ADDENDUM # 1

RE: **Pre-bid Minutes Clarifying Scope of Work**
Contract ID: DN00561
County: Transylvania
Letting Date: June 12, 2018

SUBJECT: Project DN00561: Brevard Academy Pre-Bid Minutes

**DN00561 : Brevard Academy Project Pre-bid Meeting Minutes
Transylvania County, June 4, 2018 at 10:00 AM**

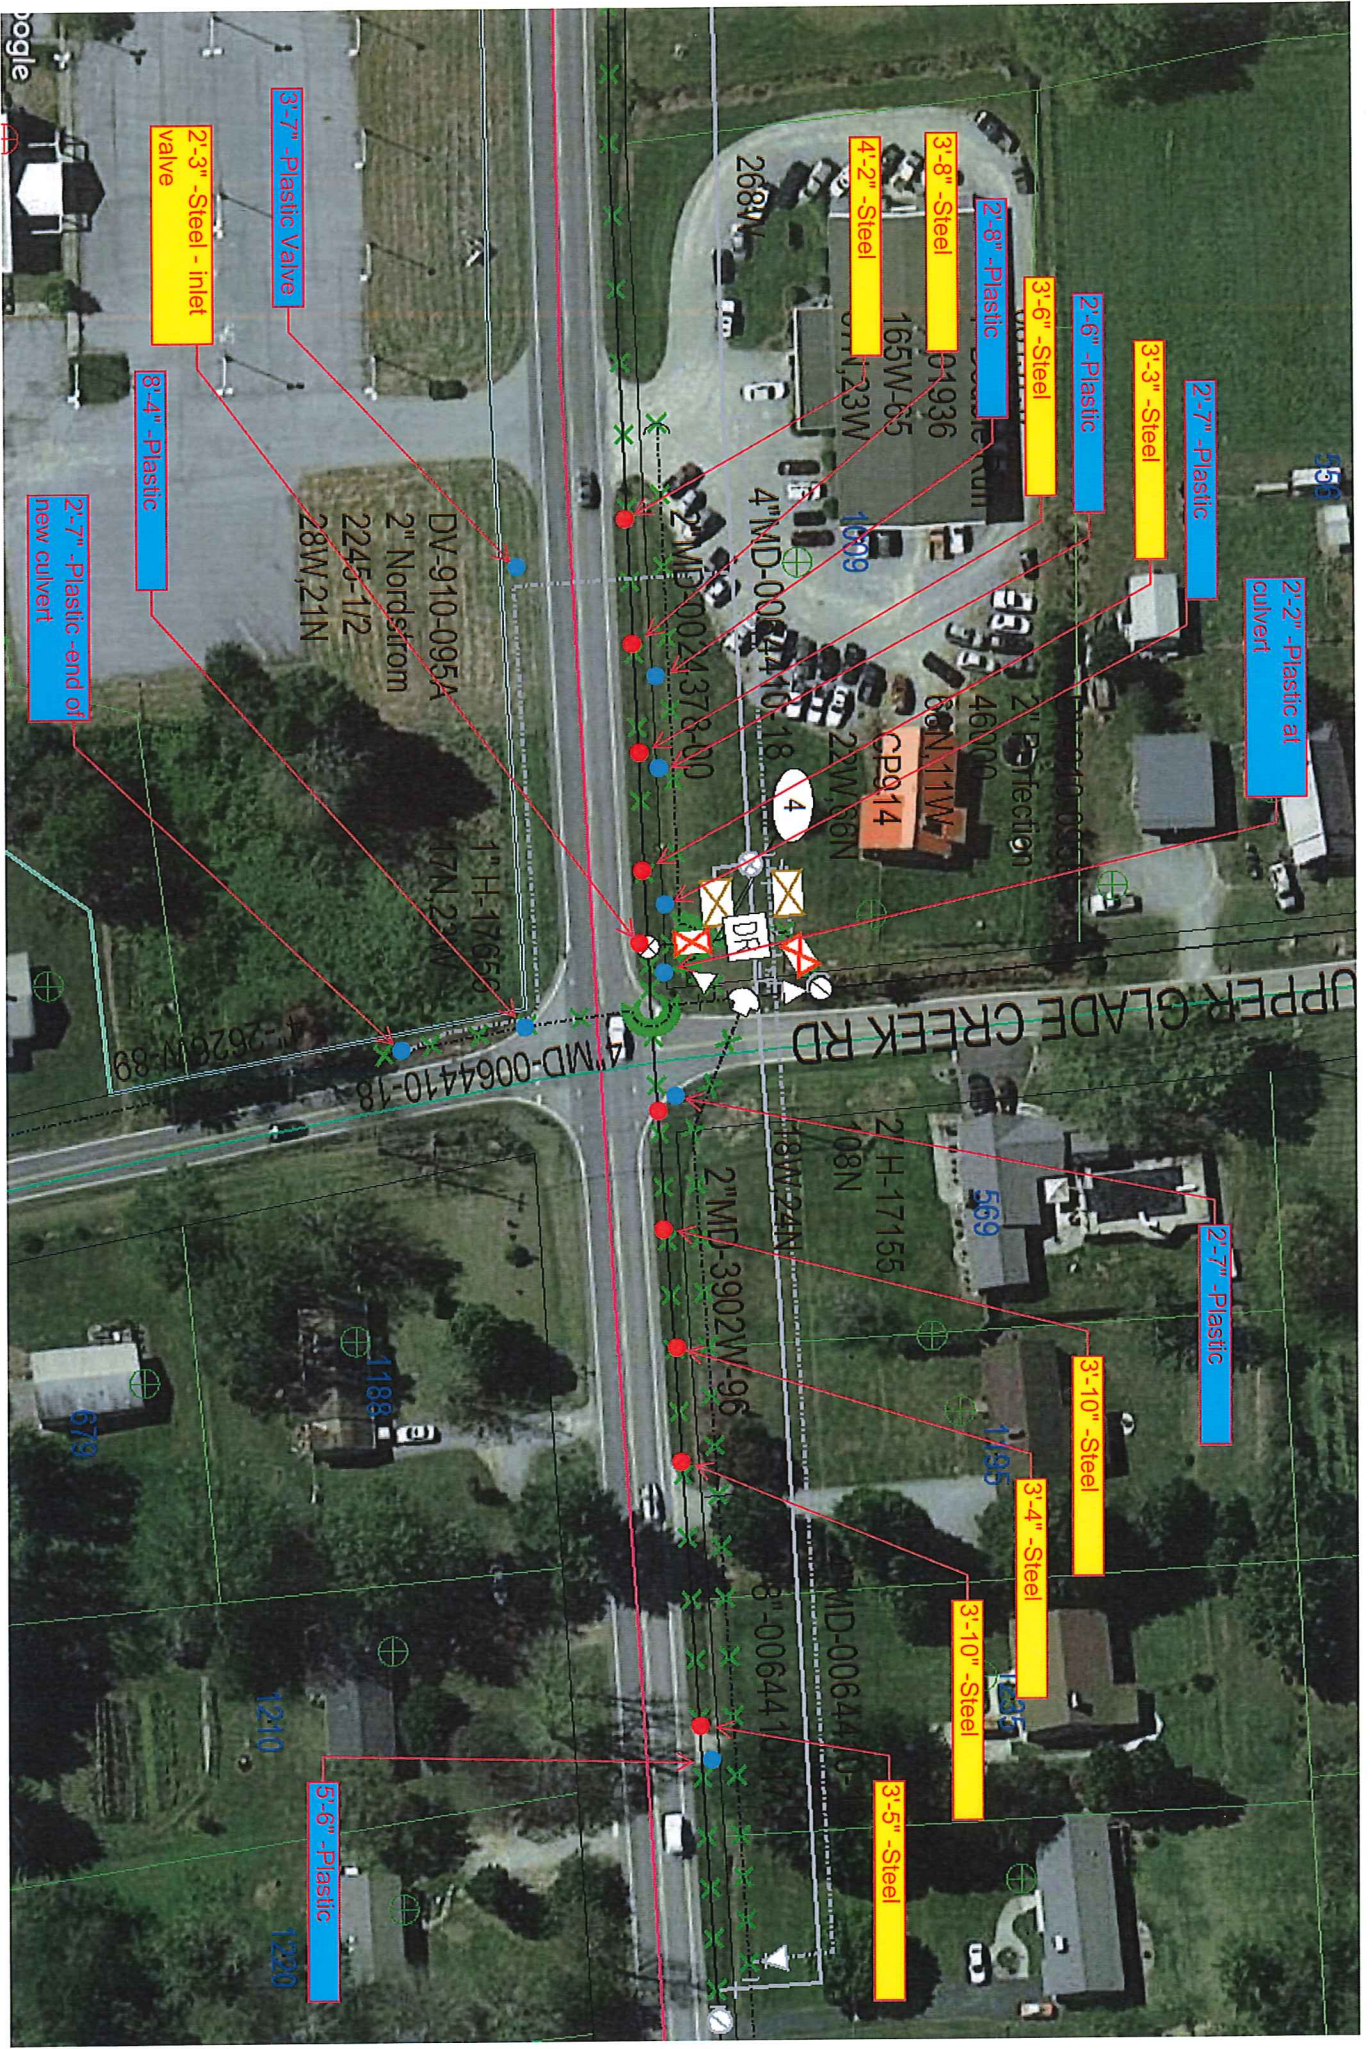
Per your request, we have investigated the integrity and status of our M-228 steel high pressure line on US-64 across from Brevard Academy. This investigation focused on depth, location, corrosion and leaks. We reviewed any past leaks and/or repairs to the line and found the pipe to be in good condition. The line depths, shown in yellow on the attached drawing, were adequate considering the proposed shoulder will be fill.

As a result of this investigation, we request the option of leaving the line in-place, located on the edge of the proposed paved shoulder. Access for maintenance, in the event of a future leak or concern would be reasonable and would require standard traffic control measures. PSNC Energy shall continue to operate this line in accordance with our O&M procedures.
